CITY OF MERCER ISLAND

Re: Review Letter for CAO18-003 - Critical areas Determination
Regarding: possible piped watercourse and the type IV wetland located at 8114 West Mercer Way Mercer Island, WA 98040; Parcel ID: 33585-00974

Land Use Review Comments:

date July 26, 2018
to Lauren Anderson, Assistant Planner
from Jessica Redman, Ecologist
subject Lee Residence (CAO18-003) Critical Areas Review

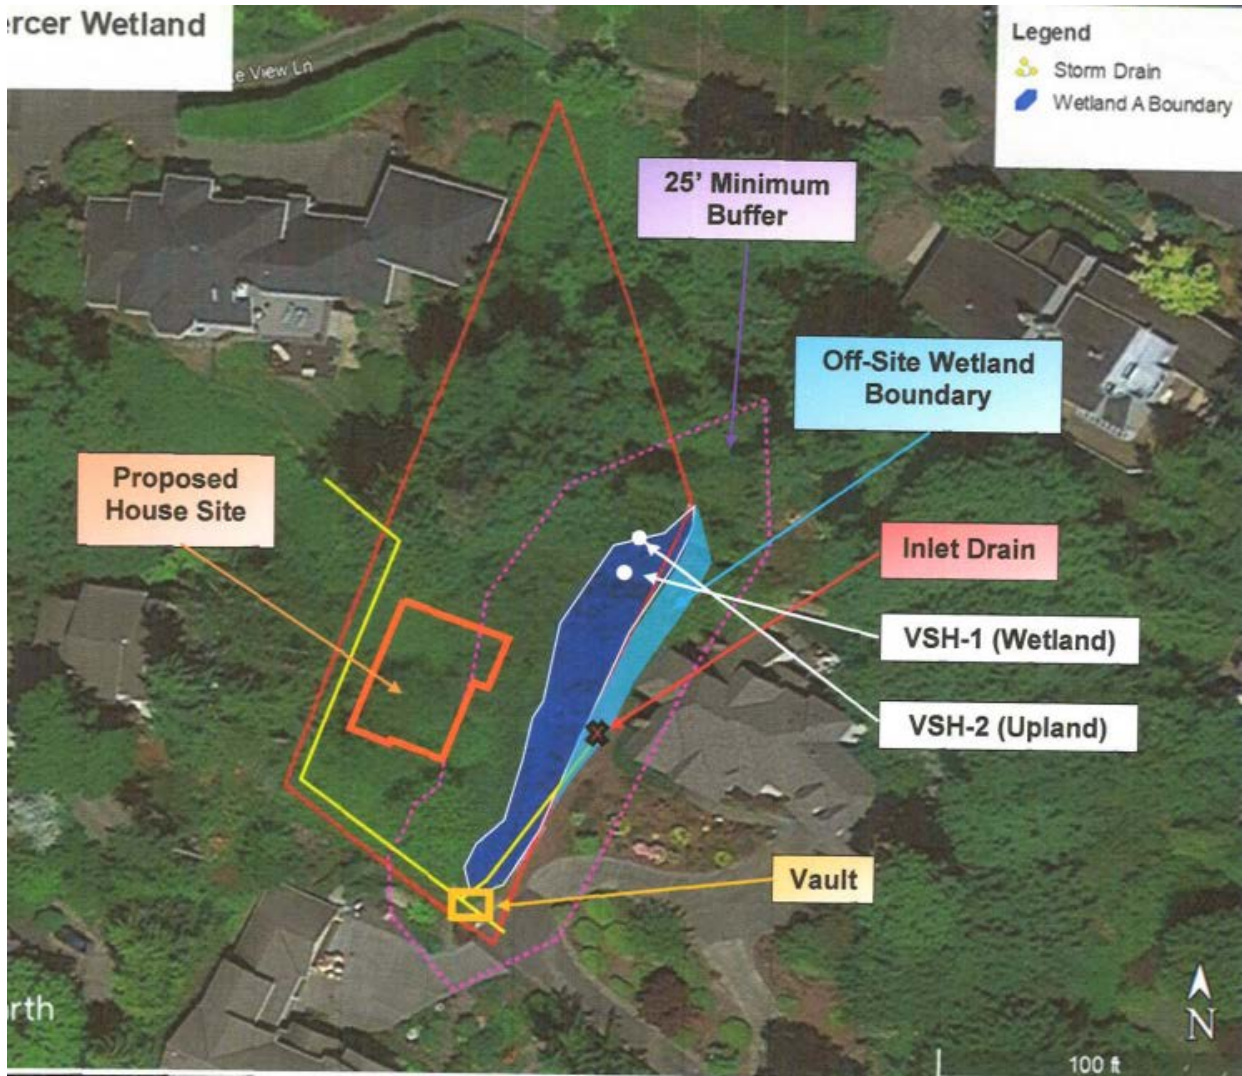
Lauren, I wanted to reach out regarding the proposal CAO13-03. I am the owner of 8122 W. Mercer Way, the property directly below the proposed changes to the minimum buffer. I have some significant concerns regarding the proposal and the vague nature of both the proposal and the impact. If they are proposing a reduction of the minimum buffer in some areas, where is the impact analysis to overall erosion and potential damage down-hill to our property? Also, what is the proposed plan to compensate for the reduction of the wetlands in the proposal?

In addition, we consulted with another consultant who informed us that the outline below is missing another wetland on the property. I would like to request an additional survey to ensure that all wetland impacts and potential damage to both the environment and to our property are understood, taken into account and mitigation plans developed.
